May 6, 2014

Re: *North American Electric Reliability Corporation*

**NOTICE OF FILING OF THE
NORTH AMERICAN ELECTRIC RELIABILITY CORPORATION
OF REVISIONS TO THE DEFINITION OF “BULK ELECTRIC SYSTEM”**

NERC Figure A Networked Configuration w/ a 50 kV (or less) Loop

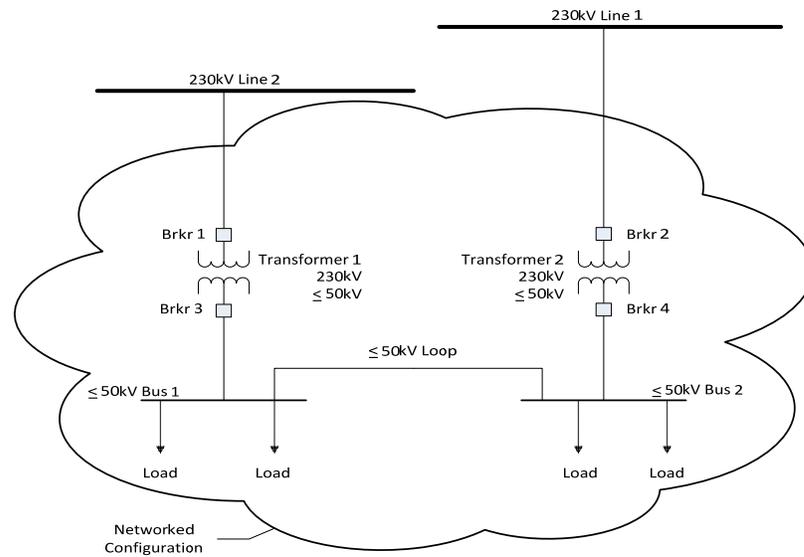
In consideration of FERC’s directives, Exclusion E1 has been revised to include Note 2. Note 2 to Exclusion E1 states that the “presence of a contiguous loop, operated at a voltage level of 50 kV or less, between configurations being considered as radial systems, does not affect this exclusion.” Under the Phase 1 BES Definition, the presence of a loop meant that a configuration would be ineligible for consideration under Exclusion E1 and instead would have to be considered under Exclusion E3. Note 2 functionally allows for a configuration with a loop of 50 kV or less to qualify for Exclusion E1– this is illustrated below in Figure A.

This improvement to the BES Definition is responsive to FERC’s concerns in Order Nos. 773 and 773-A. FERC stated in Order No. 773-A that “[i]t strikes us as unreasonable to characterize lines as radial by ignoring connecting facilities below 100 kV.”²⁹ Instead, Note 2 recognizes the physical realities of the interconnected transmission system. For example, it would be an illogical result for two otherwise radial systems connected by a 2 kV loop to be

Note 2 – The presence of a contiguous loop, operated at a voltage level of 50 kV or less, between configurations being considered as radial systems, does not affect this exclusion.
